SURVEY FOR  
**U.S. FOREST SERVICE**  
**SMITH-UMP CADASTRAL**  
**CONTRACT NO. 53-04T0-3-0935N**  
**SECTION 33, T21S, R11W, W. M.**  
**DOUGLAS COUNTY, OREGON**

SMITH - UMP CADASTRAL

This is in response to your request for our opinion concerning survey procedure in T. 21 S., R. 11 W., Willamette Meridian, Oregon, as discussed in your meeting with Dan Berry on January 24, 1984.

This is in response to your letter dated January 30, 1984, concerning survey procedure in T. 21 S., R. 11 W., Willamette Meridian, Oregon.

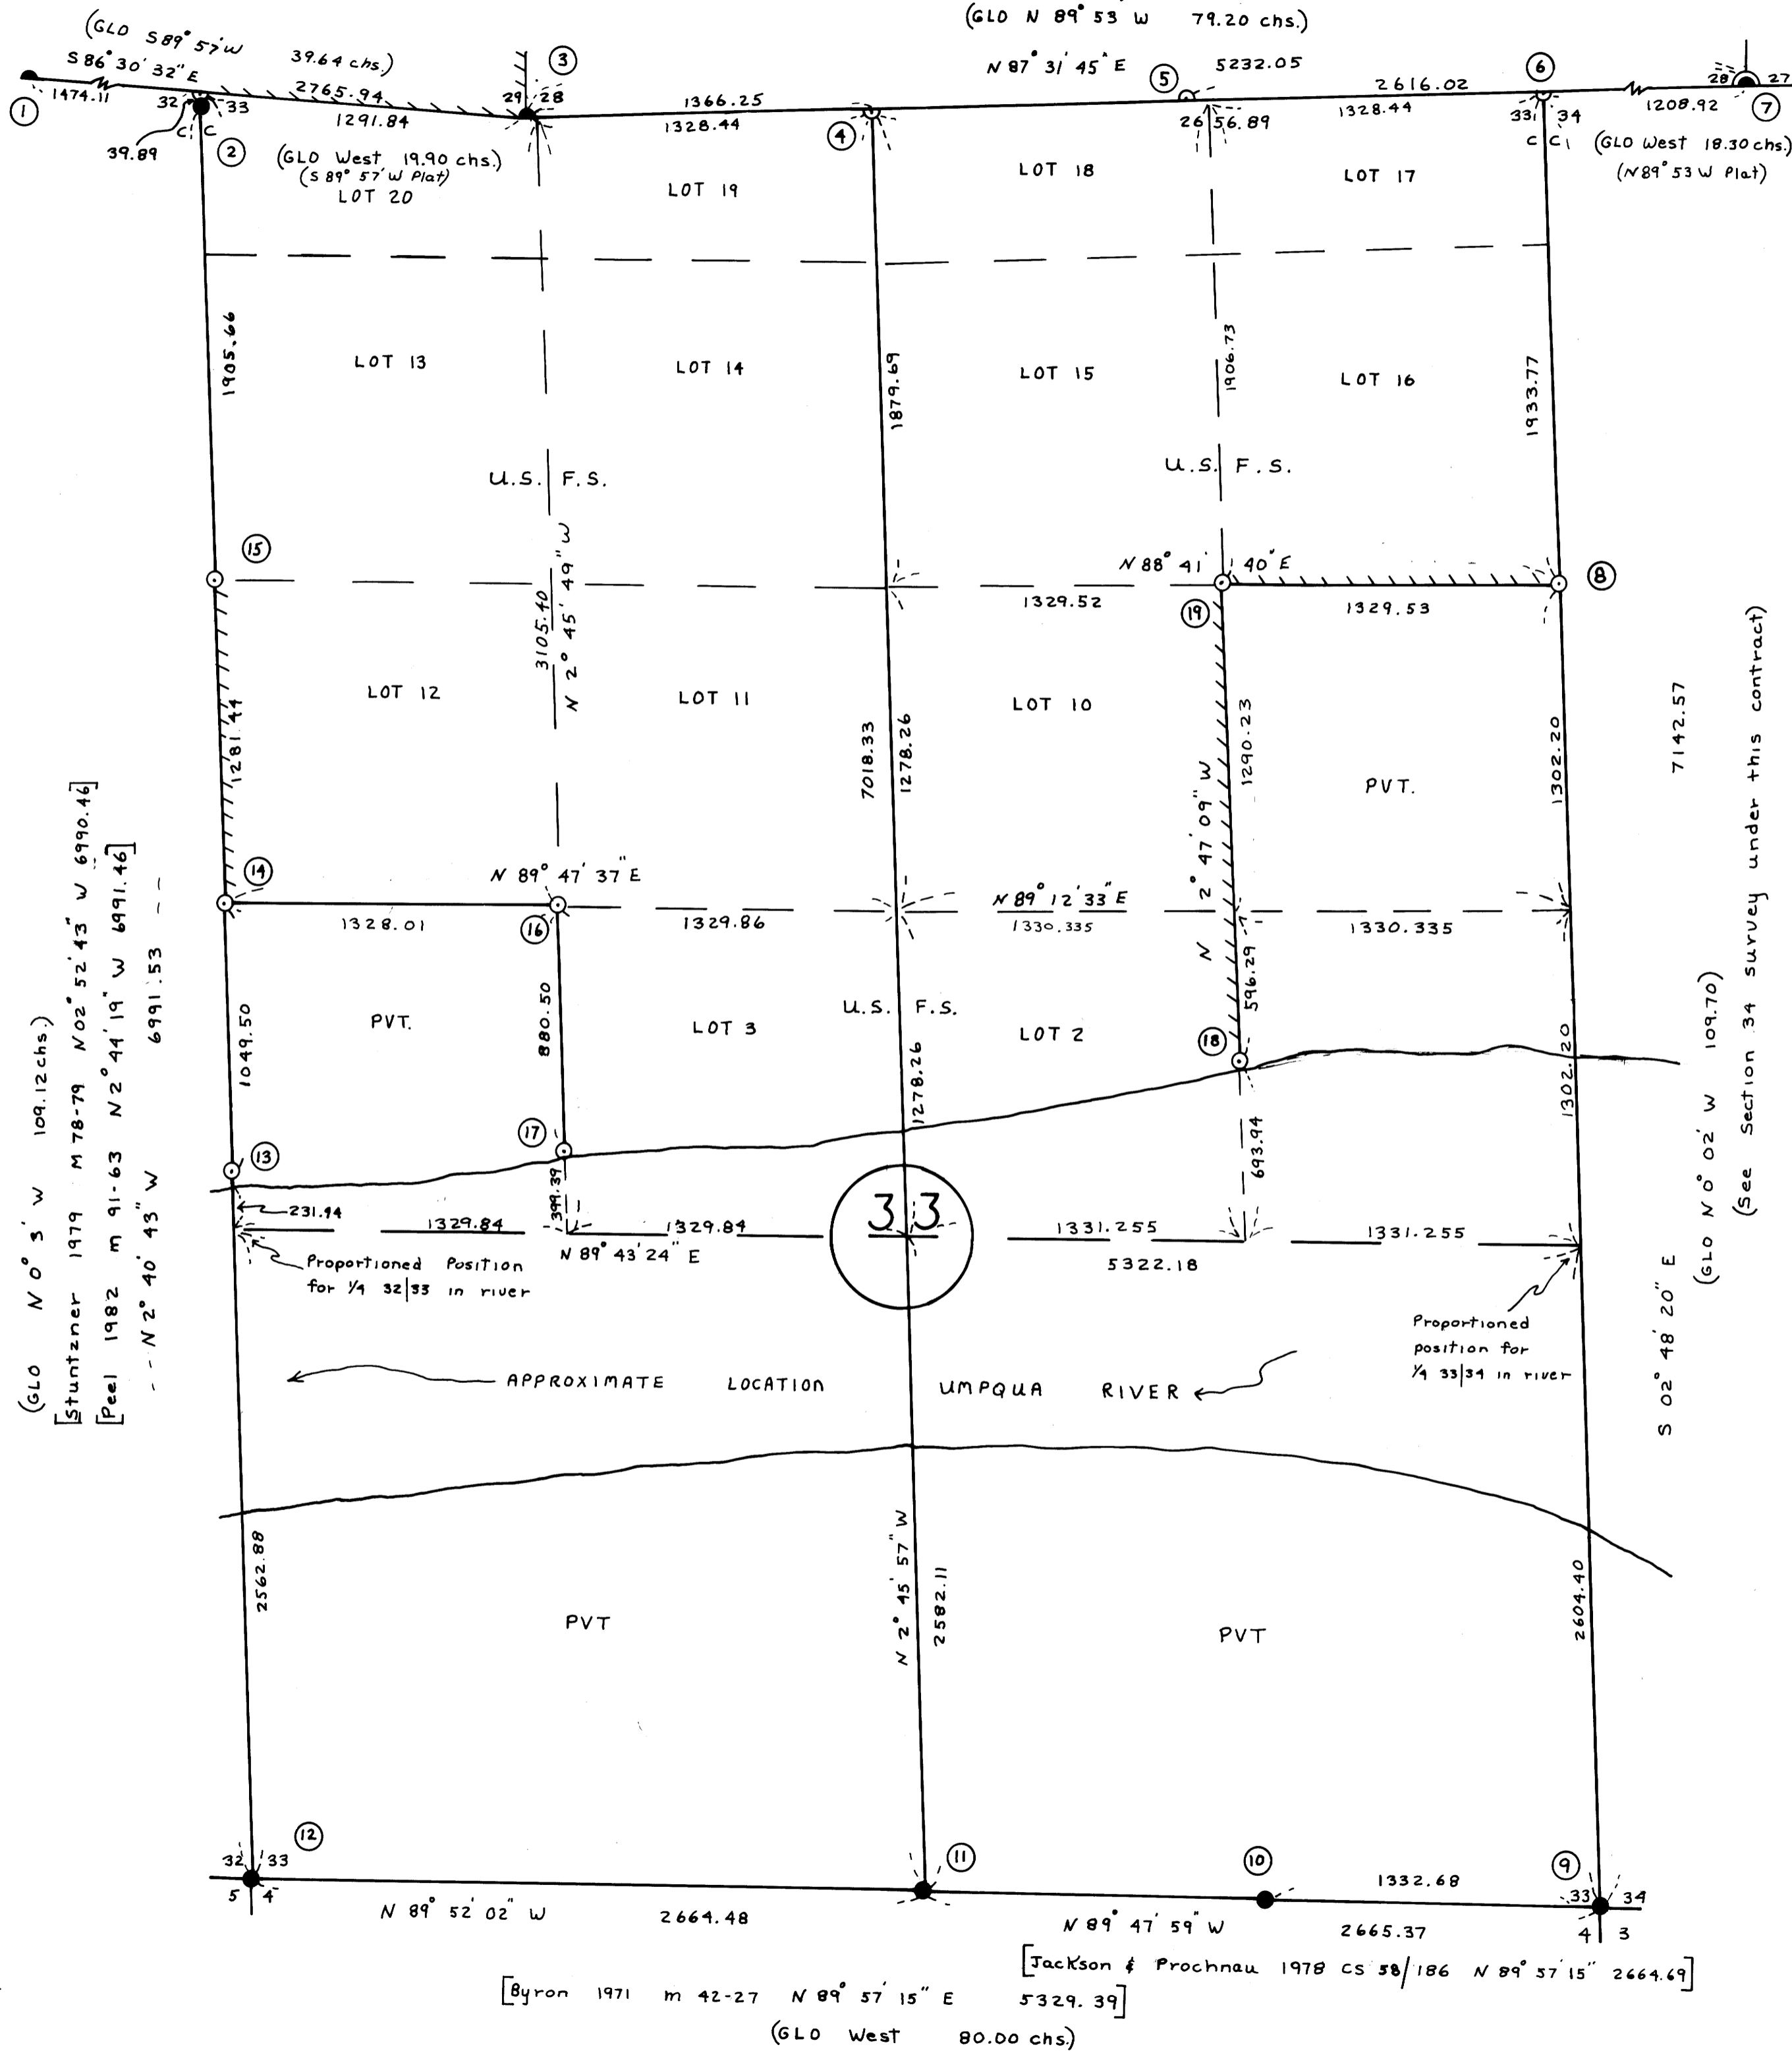
Based on the ground conditions you have developed, your submitted material contains several proposed methods, including the 1974 BLM recommendation, all of which indicate some distortion in bearings and/or distances from the original record. The 1974 BLM recommendation (your method No. 1) creates what we consider to be minor distortion in bearing but produces distances that in most cases are closer to matching the record than the alternatives; i.e., some bearing distortion gives way to generally good distance relationships.

After examining all possible methods that you have proposed, it appears that no one method can be adopted that will not create some distortion. Considering this, we feel the factor that should determine the method used is that which would normally be called for in such instances, according to the BLM Manual and common practice. Therefore, it is our opinion that the procedures outlined to Mr. Ingram in 1974, and reiterated in your letter, are still valid and would probably be used by this office if we were conducting the survey.

With regard to the monument at the  $\frac{1}{4}$  section corner of sections 21 and 28 which the BLM reestablished in 1960, and you found to be approximately 25 feet from its proper position, we feel it should remain as is. This decision is based on (1) its length of existence, (2) the fact that its position was used by a 1977 private survey, and (3) its position does not constitute what we consider to be gross error.

The problem you have posed is not to calculate the position for the southeast corner of section 34, but rather to restore the meander corner of sections 34 and 35. The point for the section corner mentioned in Byars' record falls in a meandered river and hence does not exist either in theory or practice.

The Manual (Section 5-40) prescribes that meander corners on lines projected across meandered bodies of water will usually be reestablished by single proportionate measurement (occasionally, by single point control), or in extreme cases, by adjustment of the record meanders. It also allows for special cases (Section 5-46) where the surveyor's experience and judgment may properly override or modify these principles.

There are many potential pitfalls in using control south of the river to restore the meander corner in question. You refer to some of these in your letter. Whenever possible, survey errors or discrepancies should be isolated where they "properly belong" (Section 5-23) and should not effect proportioning of lost corners beyond their immediate area. In line with this principle, projecting Byars' survey across the river through his 23.22 chain triangulation would probably introduce more error than using his 17.89 chain tie to the  $\frac{1}{4}$  section corner.

In addition, it makes little sense to extend possible distortion from questionable corners, which are 74 to 96 chains away, across a river, and in another township, when the original  $\frac{1}{4}$  section corner of sections 34 and 35 is much closer, probably more reliable, and in the same township. While certain aspects of Haines' work are debatable, it is not necessary to pass judgment on his survey one way or another, as the method we suggest for restoring the meander corner ignores his survey and conforms to the Manual.

A second best solution might be to reestablish the meander corner by single proportionate measurement between the corner of sections 3 and 10, T. 22 S., R. 11 W., and the  $\frac{1}{4}$  section corner of sections 34 and 35, since these two seem generally accepted as original corners. From your data, it appears that such a restoration would place the meander corner about 8 links south and 30 links west of a point at record bearing and distance from the  $\frac{1}{4}$  section corner of sections 34 and 35. The two locations are favorably related and tend to confirm one another, but all things considered, a single point control restoration is preferable.

In our opinion, the meander corner of sections 34 and 35 should, in this case, be reestablished at record bearing, South, from the original  $\frac{1}{4}$  section corner of sections 34 and 35, and at record distance, 17.89 chains, from the  $\frac{1}{4}$  section corner if this distance places the meander corner on or very near the present meander line. If the record distance falls close, but not on the meander line, the present shoreline may be treated "as an identified natural feature" (Section 5-40) and the meander corner reestablished on it.
